SAFETY RECALL ACTION

Reference number:	RA-07-0024	Issued: 6 July, 2017
Subject:	Connector failure on V8 Vantage 7-Speed SportShift II Transmission	
Model(s):	V8 Vantage and V8 Vantage S with 7-Speed SportShift II Transmission	
VIN range:	Refer to the separately published list of VINs	
Applicable to:	All Dealers (Not USA)	
Distribute to:	After Sales Manager Executive Manager Service Manager Sales Manager	Warranty Staff Technician(s) Parts Staff

Safety Recall Action RA-07-0024 – Connector failure on V8 Vantage 7-Speed SportShift II Transmission

Figure 3

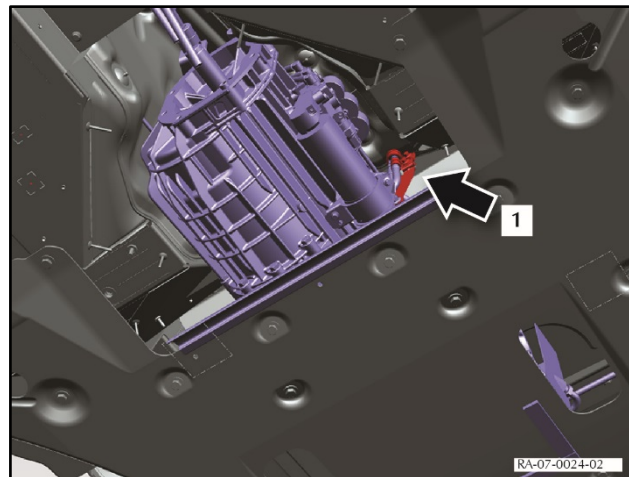
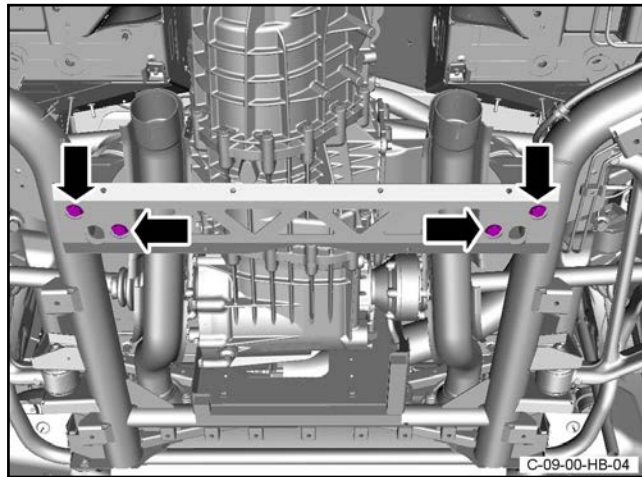
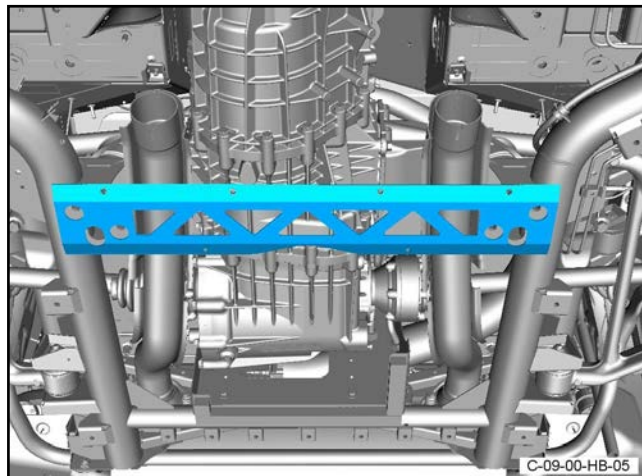
2. Examine the connector on the clutch supply line. If the bracket (1) shown in Figure 3 is installed, you do not need to do more work. Do Step 4.

If the bracket is not installed, continue from Part B.

Figure 9

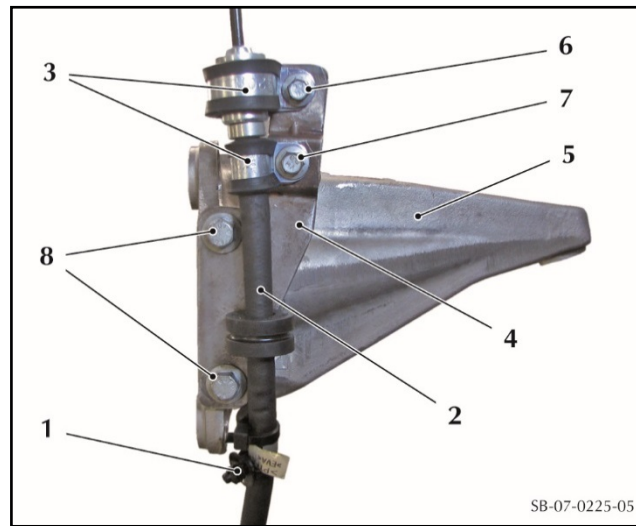
16. Cut and remove the fir-tree fixing (1) that attaches the ASM hose assembly (2) to the transmission (refer to Figure 9).
17. Install the two P-clips (3) onto the ASM hose assembly (2).
18. Put the new ASM hose bracket (4) in position on the transmission mounting bracket (5).
19. Loosely install the screw (6) that attaches the top P-clip to the ASM hose bracket (4).
20. Align the top P-clip (3), the ASM hose bracket (4) and the ASM hose (2).
21. Align the ASM hose bracket (4) with the holes in the transmission mounting bracket (5). Install and tighten the two attachment screws (8).

22. Put the bottom P-clip (3) into the correct position and loosely install the attachment screw (7).
23. Make sure that the P-clips (3) and the ASM hose assembly (2) are correctly aligned and tighten the two P-clip attachment screws (6 and 7).
